POST REPLACEMENT – refer to original approved shop drawing 2141 for additional notes & info

ITEM 525.33 BRIDGE RAILING, GALVANIZED 2 RAIL BOX BEAM (S-360A)
ITEM 621.72 GUARDRAIL APPROACH, GALV 2 RAIL BOX BEAM (S-360B)
TOWN OF LUDLOW, VERMONT
VT ROUTE 100 – (MINOR ARTERIAL) BRIDGE #99
WINDSOR COUNTY STP DECK (39)

NSC CERTIFIED FABRICATOR
NSC JOB NO. 2141C
SHEET NO. 1 of 1

RAILING POST W6 x 25 x height varies w/ 1 x 10 x 14 BASE PLATE (GLV)

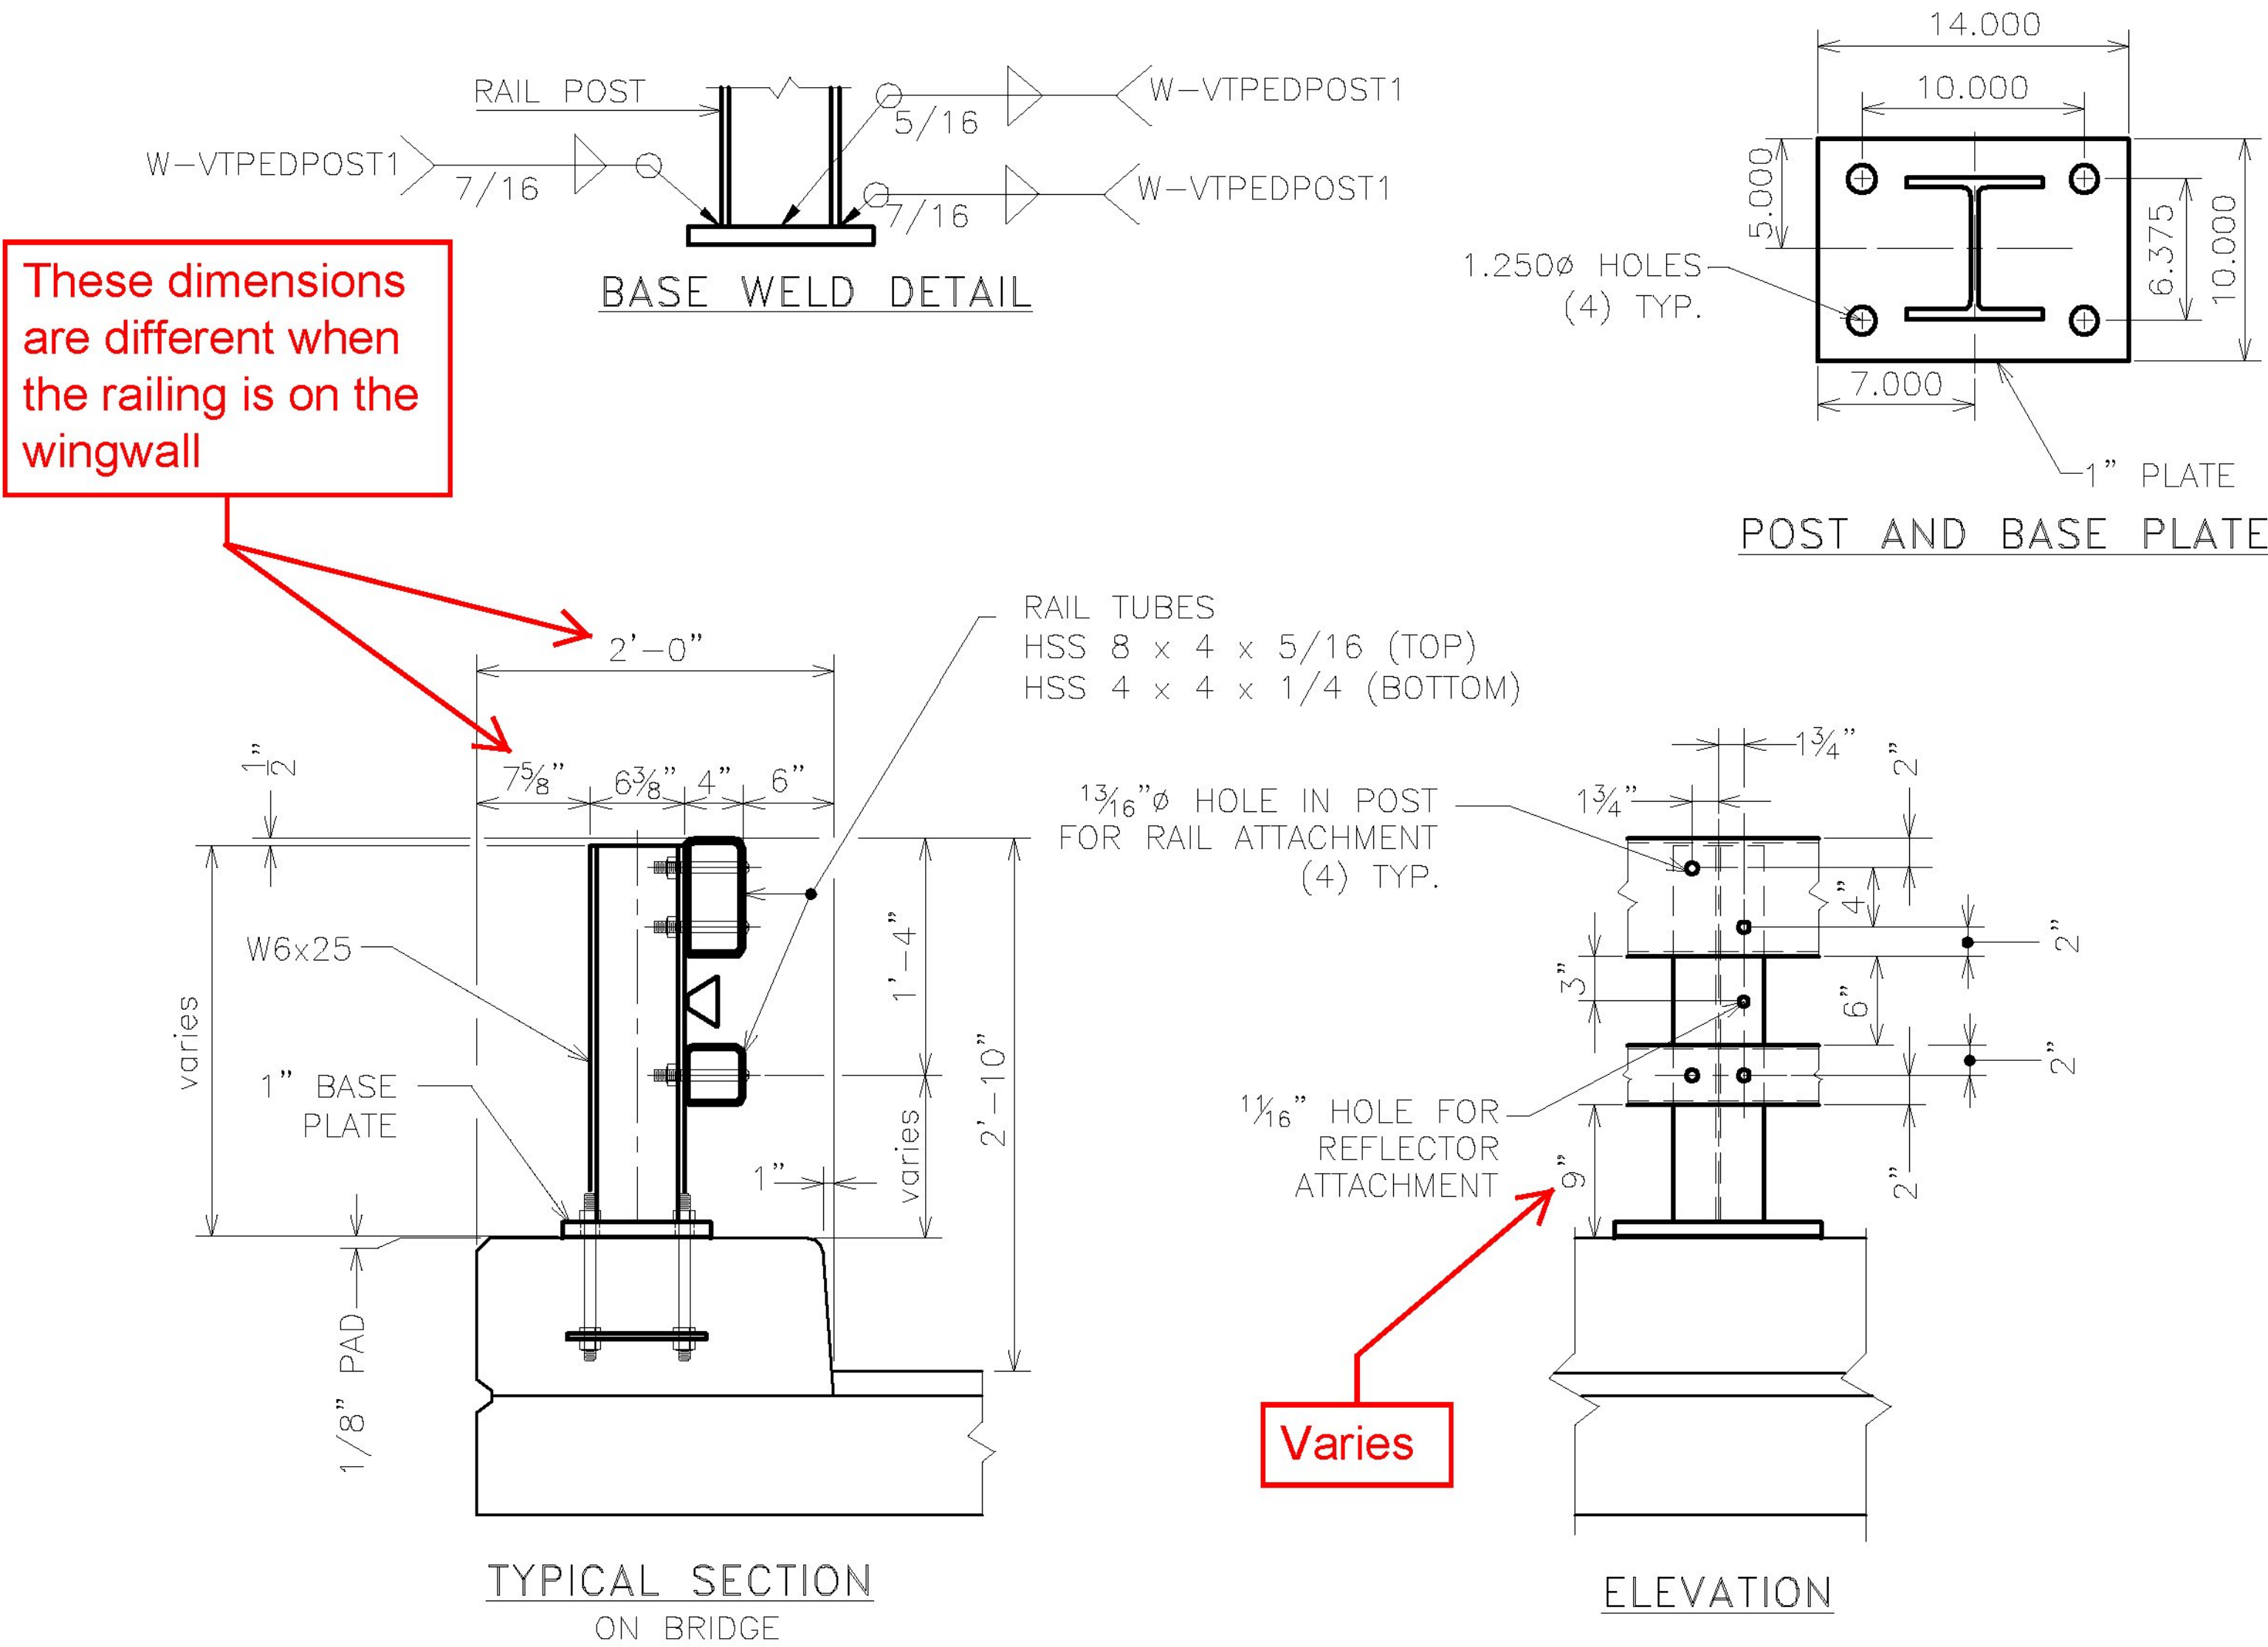
Vermont Agency of Transportation
RECEIVED
CK'D BY CLD OK'D BY TAS
June 20, 2017
RESUBMIT no Approved AsNoted
BY Todd Sumner DATE 06/21/17
